ADDENDUM NO. 3  
To the Contract Document and Project Specifications for the

**South Side Athletic Annex Baseball and Locker Improvements  
Fort Wayne, Indiana  
April 6, 2026**

3. Plan Sheet C7.2 – Site Details Sheet II

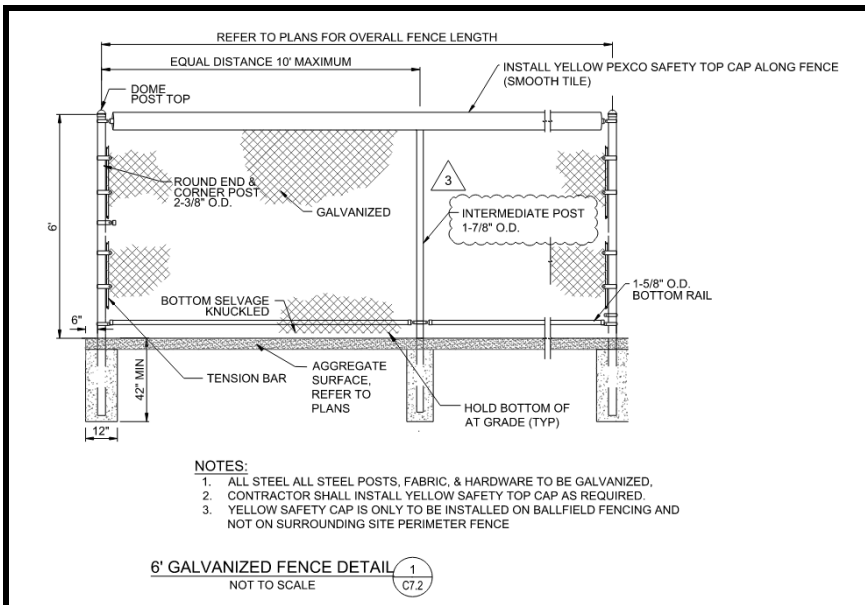
**REVISED:** Intermediate post callout on the 6’ galvanized fence detail (Detail 1) updated to specify 1-7/8” O.D. post size.
